Bulletin No. 2003-08

Electric Oil Pump No Longer Available (NLA)

Mercury/Mariner	Serial Number or Year
OptiMax Outboard 135 thru 225 HP	S/N 0G590000 Thru 0G960499 1998 and 1999 Models

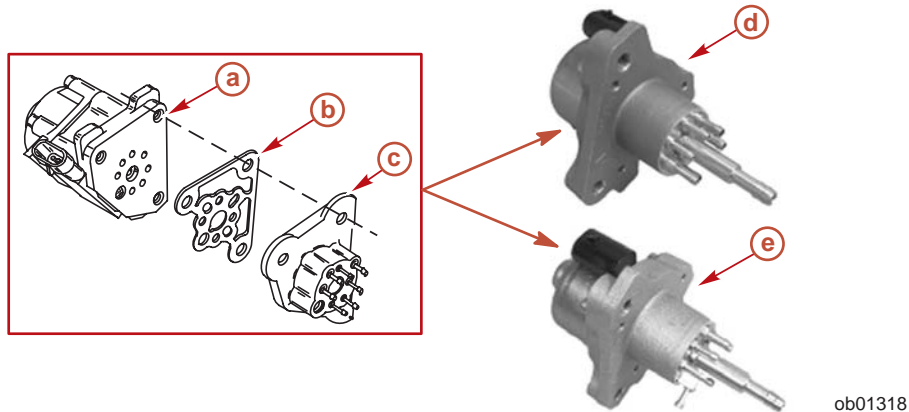
The original oil pump for the above listed models is No Longer Available (NLA). New oil pump kits using the new style oil pump will replace the original pump. The new kits replace the old pump, gasket, and bracket assembly. The bracket assembly contains the oil hose fittings which are different between the 2.5 and 3.0 liter engines. Because the fittings are different, 2 different oil pump kits are required. The new oil pump kits contain the new oil pump, wire harness adapter to convert the 4 pin connector to a 2 pin connector, and installation instructions.

a - Oil pump (old style)
b - Gasket
c - Bracket

d - New oil pump 2.5 liter
e - New oil pump 3.0 liter

Description	Part Number
Oil pump kit 3.0 Liter 200/225 HP	859373A01
Oil pump kit 2.5 Liter 135/150 HP	859372A01
